October 3, 2011

**Re: Proposed Overbank Removal Boundaries and Sample Results
Operable Unit 3, Reach L
Hayton Area Remediation Project**

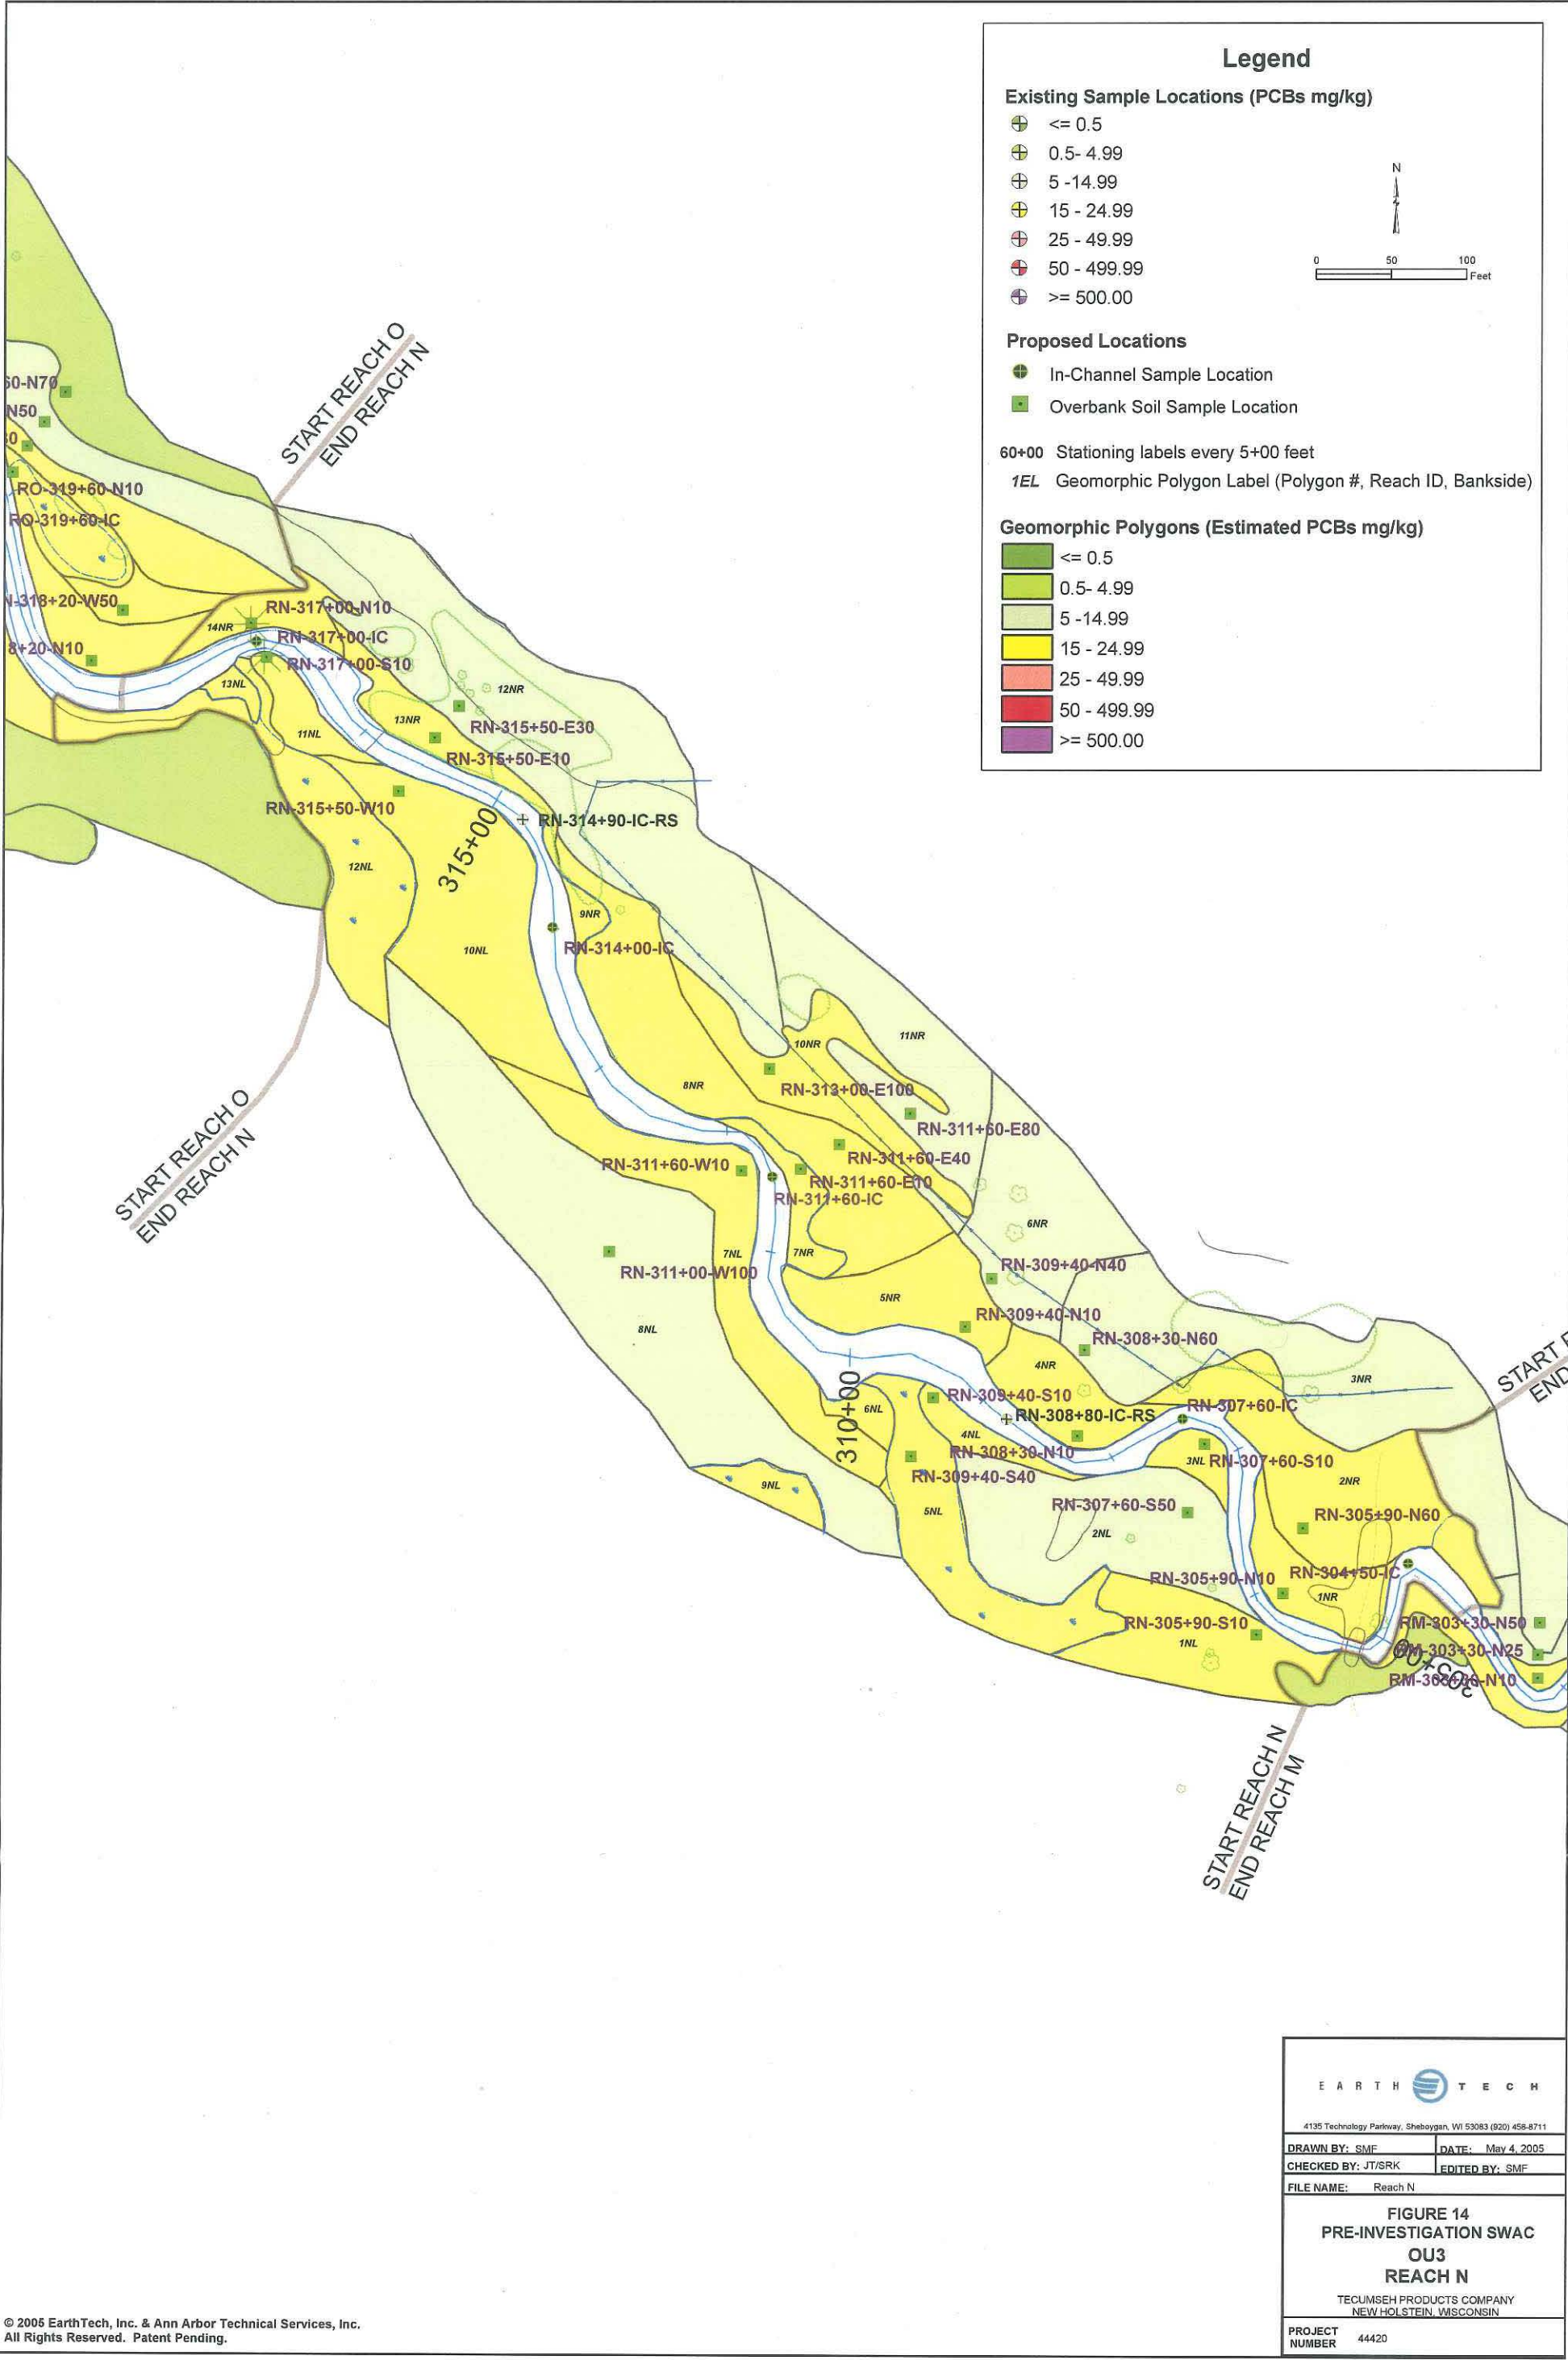
| Polygon | Similar Polygon Identified in Original Sampling Plan and Results from Sampling Similar Polygon |
|---------------|---|
| 8PR | 3PR 12/0.083; sampled 11.3; southern part identified for removal |
| 4PR | There are samples taken at the boundary between 4PR and 1PR and 6PR. Since these are boundary samples, I identified this as having no sampling. |

Comment [jmg1]: I have it identified as no samples in 10PR based on its location in 6PR.
